Rezoning Transportation Analysis

Petition Number: 2018-155

Date	Description
01-18-19	First Review

See cross-section below:

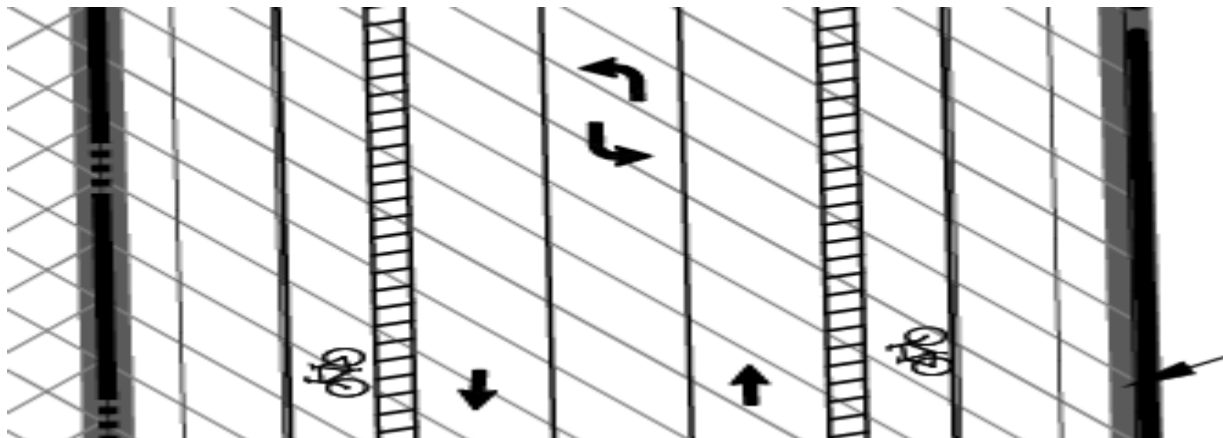
3. The petitioner shall revise the site plan and conditional notes stating the commitment to building the correct cross-section of Dixie River Road. Dixie River Road is a major thoroughfare with a cross-section of:
 - a. 2-11' thru lanes
 - b. 1-11' center turn lane
 - c. 2-8' Buffered bike lanes
 - d. 2.5' curb & gutter
 - e. 8' planting strip
 - f. 8' sidewalk.
